Access Compliance Report

Public Rights-of-Way (Curb Ramps)

Intersection ID: 10018432	Main Street: WITHAM PASSAGE	Cross Street: N/A	Location:	N
ADA ID: BEE785938FCA	Ramp Type: Directional1	Initial Pass/Fail: Fail	Overall Compliance: No	Severity Score: 22.5

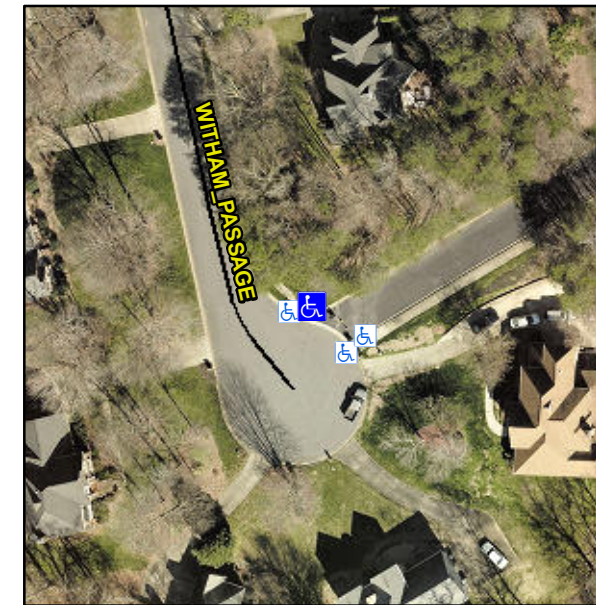
R304.5.1, R304.2.2

Compliance	Description	Data	Compliance	Description	Data
N/A	Ramp Length (in)	60.0	N/A	Grade Break?	N/A
No	Ramp Width (in)	47.5	N/A	Grade Break Slope (%)	0.0
No	Ramp Slope (%)	11.9	N/A	Grade Break XSlope (%)	0.0
Yes	Ramp XSlope (%)	2.5			
N/A	Flare Type LT	N/A	N/A	Flare Type RT	N/A
N/A	Flare Slope LT (%)	N/A	N/A	Flare Slope RT (%)	0.0
N/A	Flare Traversable LT?	N/A	N/A	Flare Traversable RT?	N/A
N/A	Landing Length (in)	0.0	N/A	DWS Provided?	N/A
N/A	Landing Width (in)	0.0	N/A	DWS Contrast?	N/A
N/A	Landing Slope (%)	0.0	N/A	DWS Length (in)	N/A
N/A	Landing X Slope (%)	0.0	N/A	DWS Full Width?	N/A
N/A	Landing Curb? (Y/N)	N/A	N/A	DWS Offset LT (in)	N/A
N/A	Shared Landing?	N/A	N/A	DWS Offset RT (in)	N/A
N/A	Gutter Ponding?	0.0	N/A	Gutter Slope (%)	N/A
N/A	Gutter Lip Ht (in)	0.0	N/A	Gutter X Slope (%)	N/A
N/A	Painted X Walk1?	No		Road Slope (%)	6.8
	X Walk 1 Direction	To SE		Road X Slope (%)	10.0
	X Walk 1 Width (in)	N/A		Clear Space?	N/A

Remove & Replace Entire Ramp.
